ADDENDUM #4

Citrus Grove Road Phase 5
Project No. 2023-08, Bid No. 23-562

CITRUS GROVE ROAD
DESIGN PHASE V
FROM WEST SR 91 TO BLACKSTILL LAKE
ROAD

SHEET
NO.

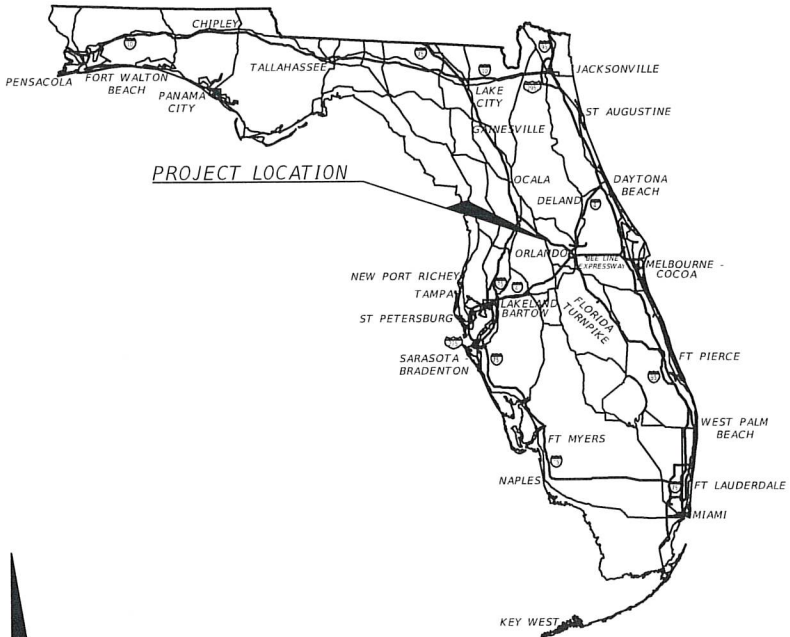
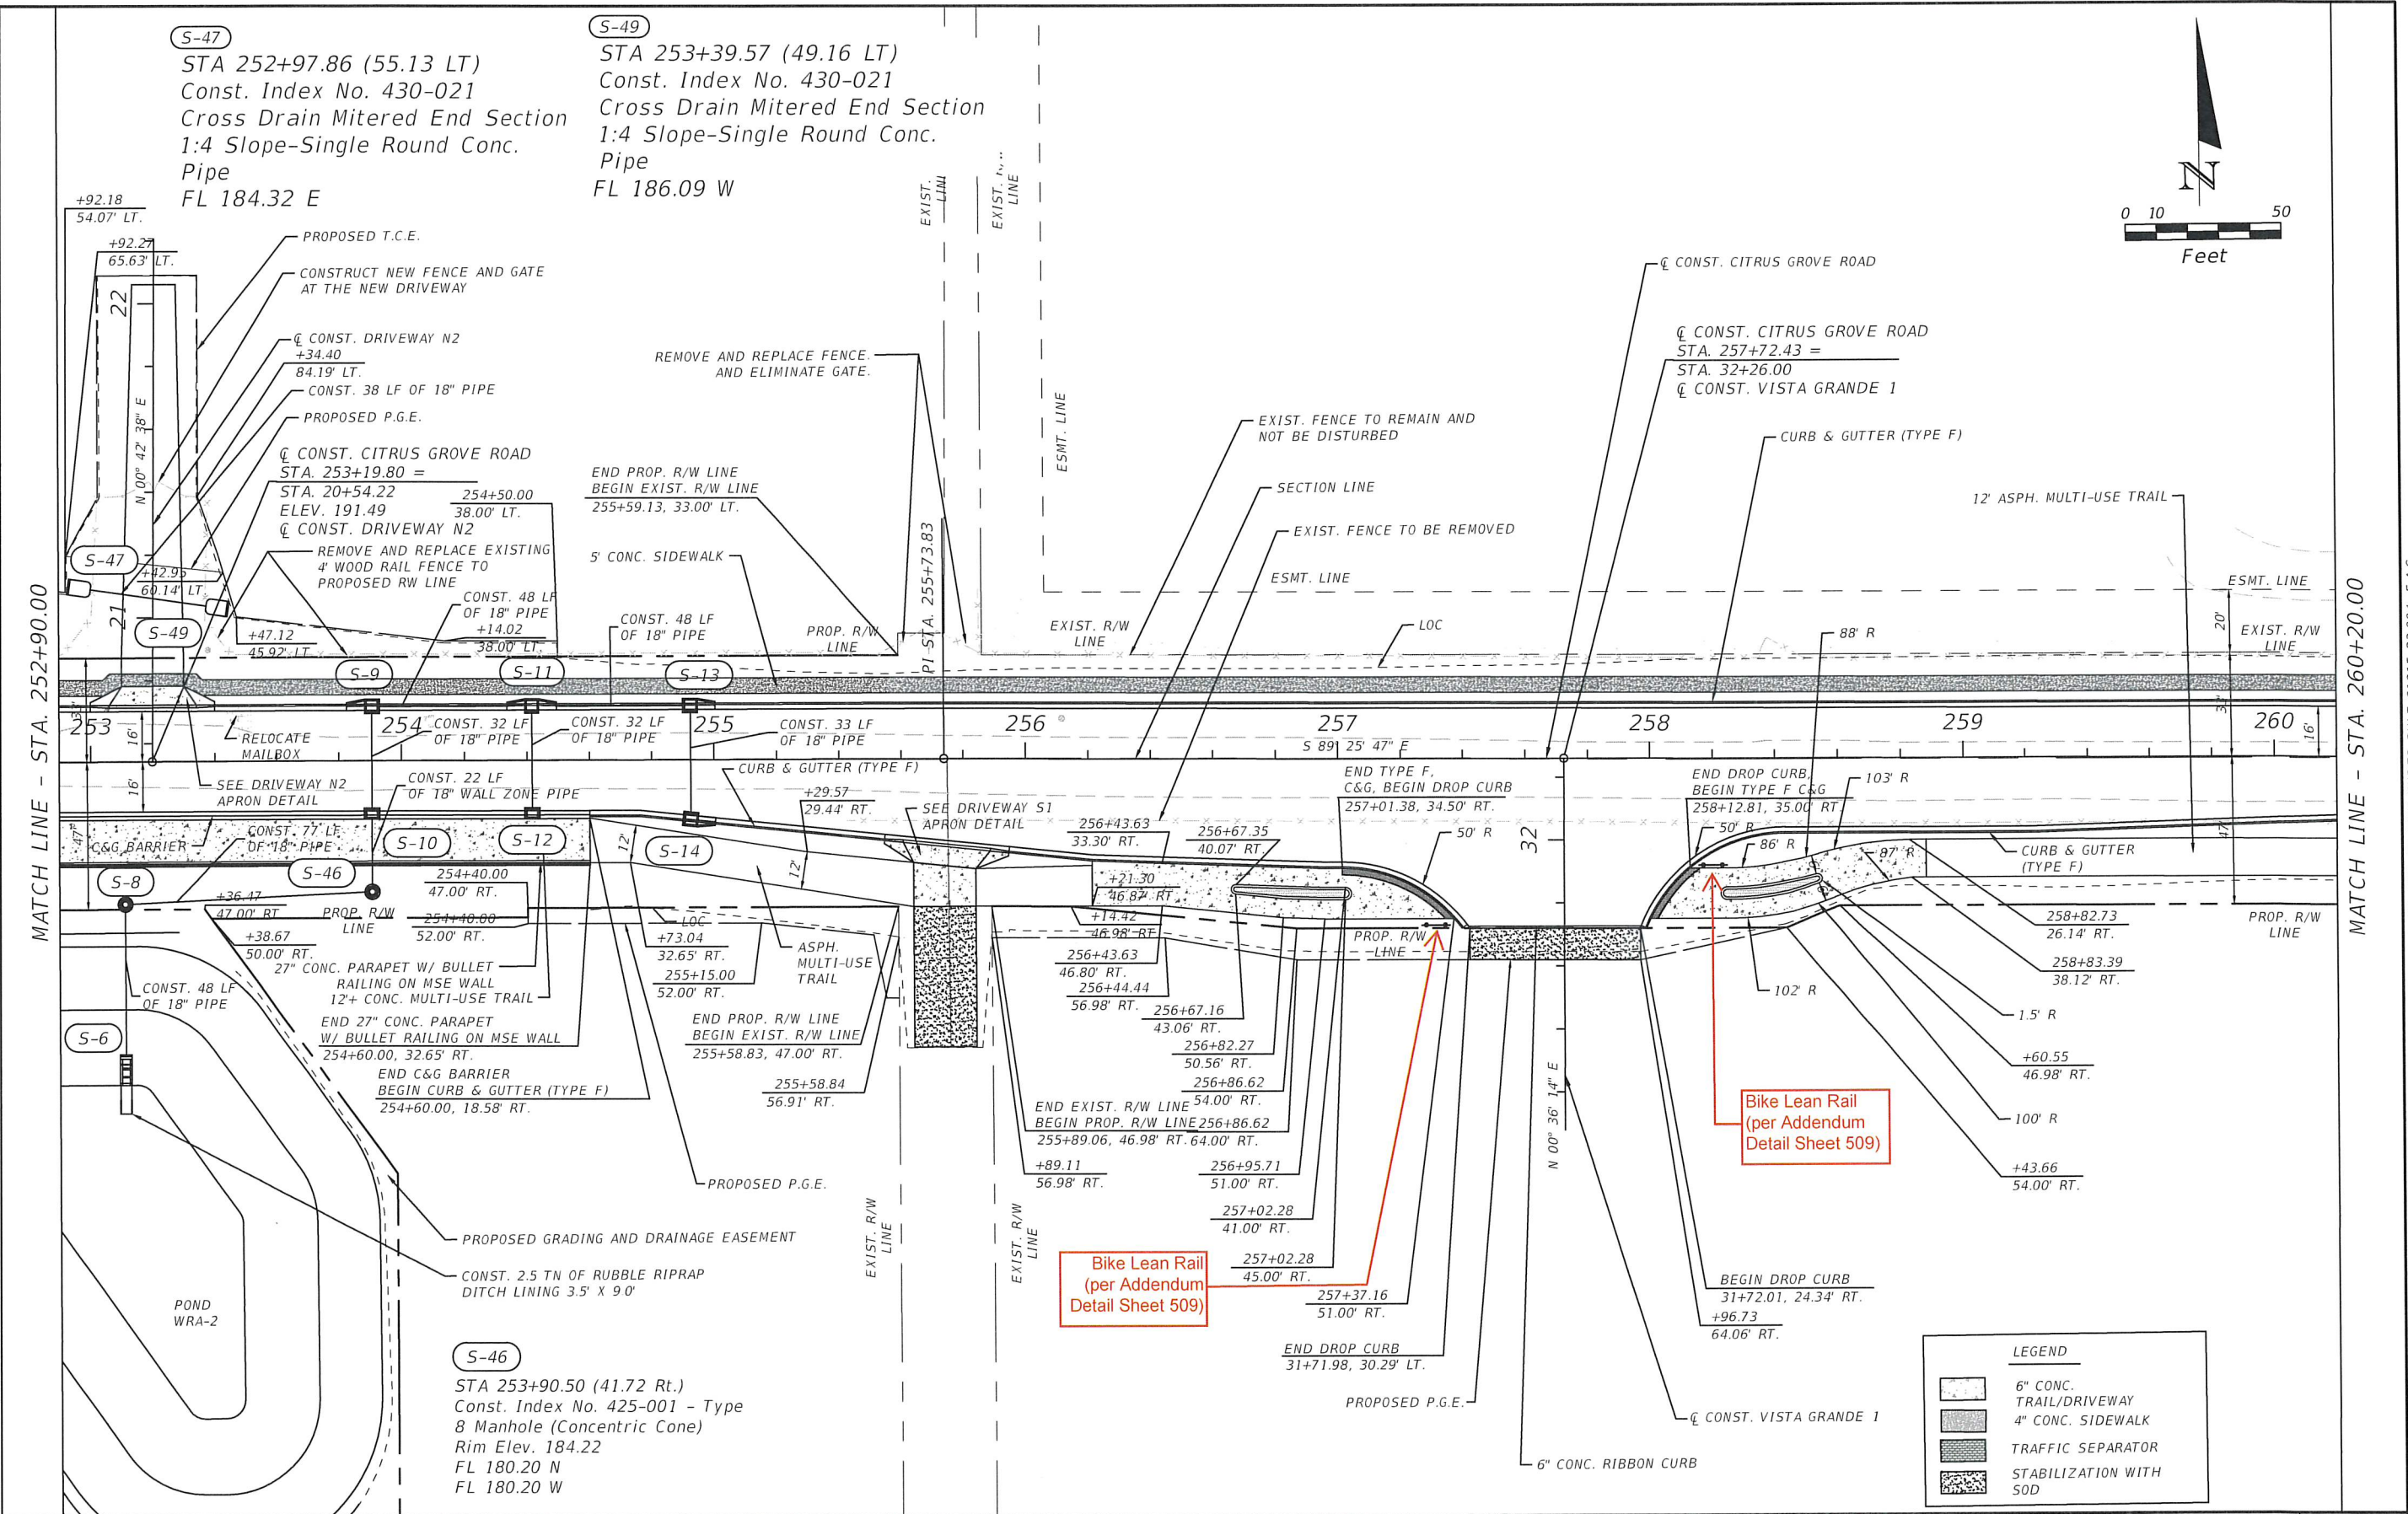
Q3: It appears that Pond WRA-3 is already built. Is this configuration acceptable or will new plans be issued detailing how this existing pond is to be reshaped?

Revisions Notes for Contractor:

1. Pond WRA-3 Will not be built with this roadway plan since it has been built with subdivision development.
2. Turnout for Pond WRA-3 at STA. 278+00 RT will not be built. Contractor to follow Typical Section for Trail and adjust in the field as necessary.
3. Pond WRA-3 when built has a bottom of 115' elevation (vs. 112' from this plan design), therefore structures S-28 & s-30 inverts have been revised. See Sheet No. 33 - Drainage Structures Tabulation.
4. There is an existing (built) masonry perimeter wall, in which the subdivision developer will remove and replace wall panel where 24" stormwater pipe from S-28 to S-30 will be located. Coordination from Contractor with subdivision developer will be required.
5. Contractor shall field adjust the 24" stormwater pipe to avoid existing wall footings.

A3: The Pond WRA-3 has already been built by Willow Ridge subdivision and has already been re-shaped; however, outfall pipe of this roadway plan needs to be built. Please see attached revised plan sheets 1, 21, 33, 35, and 63 contained within Addendum #4.

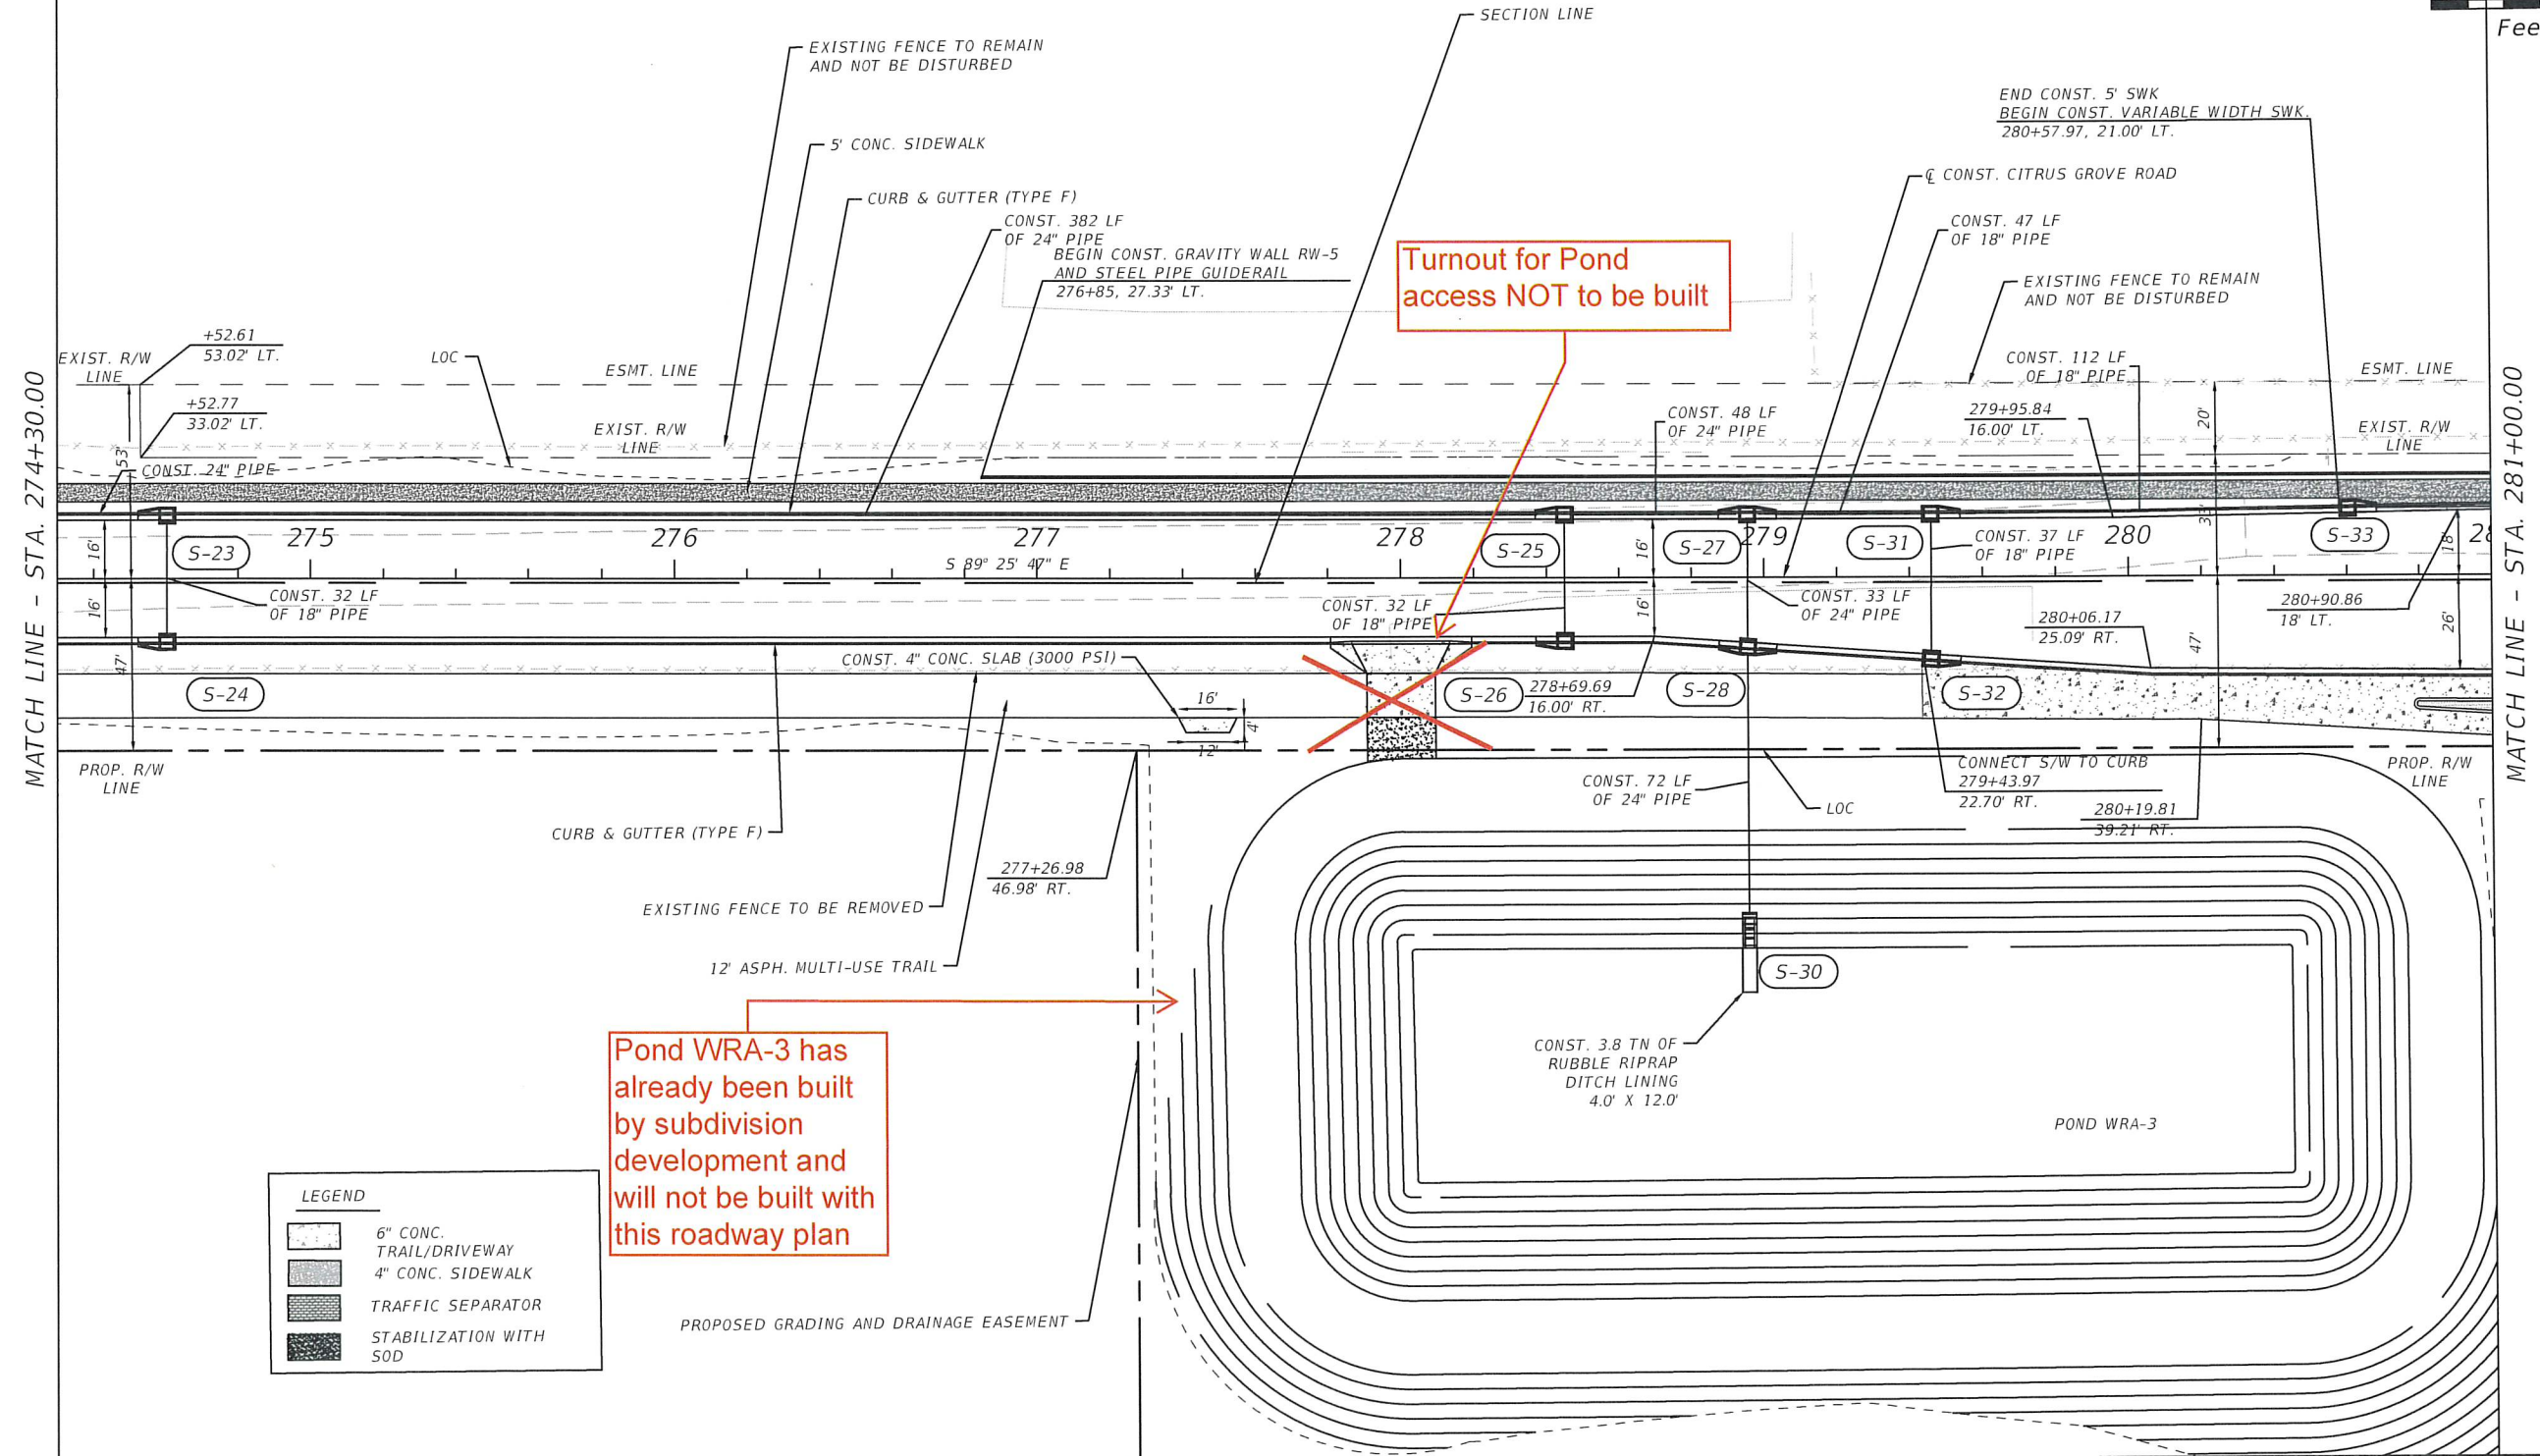
Q9: Can the location of Item 0515-2221, Pedestrian/Bicycle Railing, Steel only, 54' Type 1 be identified please?

A9: Yes, please see revised sheets 18, and 22 identifying the locations of the proposed "Bike Lean" rails. It should also be noted there is an error in the Bid Tabulation; the height of the rail should be 42" not 54' and the bid item number should be 515-1-1 Pipe Handrail- Guiderail, steel. Contractor shall use detail sheet 509 contained within this addendum to construct the "Bike Lean" rail. Contractor shall include in their bid a cost to provide a "Ribbon curb" to fasten the rail to.
